Access Review

Multi-dwelling Development
8 Linksvie Avenue Leonay
Report Issue 3
29/05/20

Excerpt from Survey of footpath gradient from proposed development to bus stop on Leonay Parade prepared by RHCO, dated 03/02/20

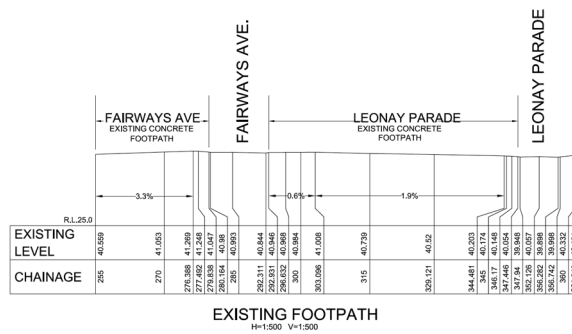
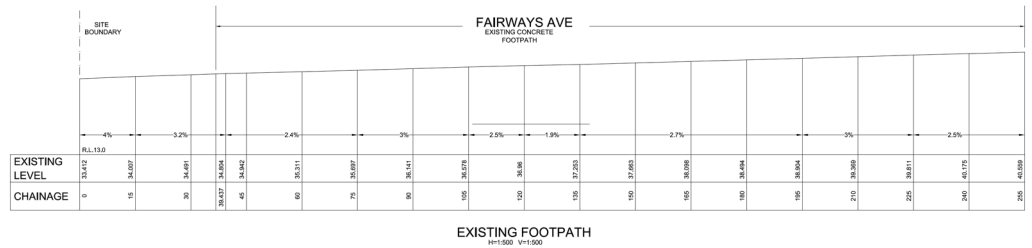
The contour and detail survey prepared by RHCO Surveyors (excerpt on following page) shows that the gradient of the existing and proposed footpath (0.6%-4%) is within the allowable gradients set out in State Environmental Planning Policy - (Housing for Seniors or People with a Disability) 2004 part 2 clause 26 of:

Based on the survey information provided and inclusion of the proposed design of the new section of footpath, in our opinion the site complies with the requirements set out in the State Environmental Planning Policy - (Housing for Seniors or People with a Disability) 2004 part 2 clauses 26 and 38 for location and access to facilities.
